NEW PRIMARY SCHOOL IN EDMONDSON PARK – RESPONSE TO PUBLIC EXHIBITION COMMENTS

PROJECT NUMBER: 210104

PROJECT NAME: New Primary School in Edmondson Park

DATE: 12/08/2021

Figure 9: Proposed location of the external mechanical plants.

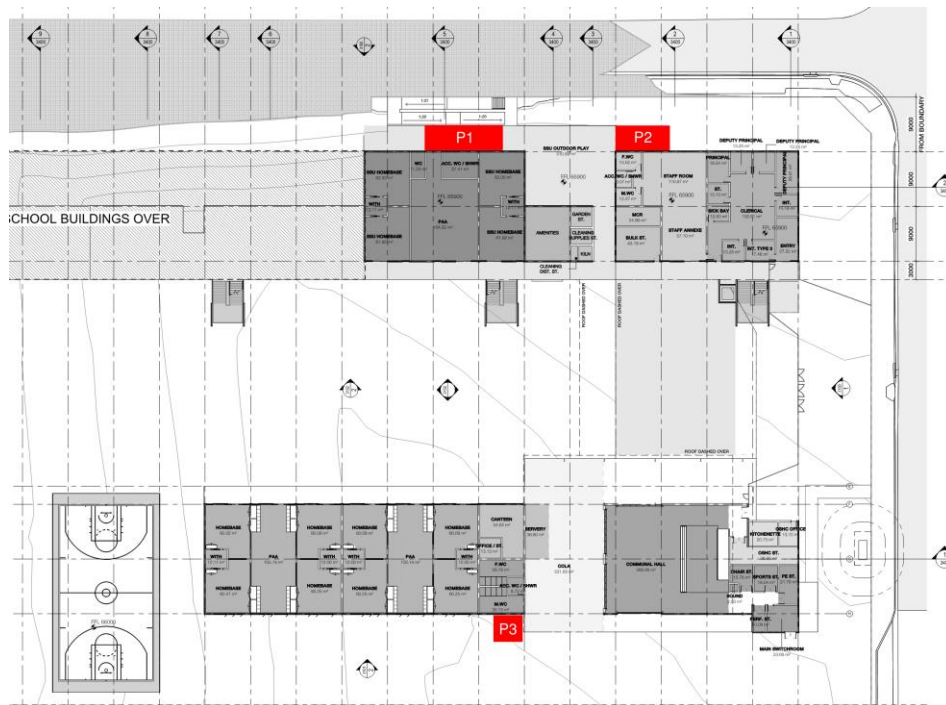
1. Given that the noise modelling is, in most cases, conducted using noise modelling software, it would be useful for the consultant to provide recommendations on an appropriate location for plant rooms and plant equipment and the maximum Sound Power Level outputs that should be for such equipment.

Based on the proposed locations of the external mechanical plantrooms, a preliminary noise impact of the external mechanical plant has been carried out. A worst-case scenario has been assumed for the noise assessment, and it includes the maximum allowable cumulative noise emissions from the external mechanical plants to the nearest residential receivers.

Noise emissions from the external mechanical plantrooms are limited in order to comply with NSW EPA Noise Policy for Industry requirements. Preliminary noise assessment of the external mechanical plant can be found in Section 5.1 of the attached updated SSDA Acoustic Report.

Residential receivers on Faulkner Way have been assumed as the most affected due to the proposed location and footprint of the external mechanical plantrooms. These noise sensitive receivers will be affected by the cumulative noise emissions from plantrooms P1 and P2 as shown in Figure 9.
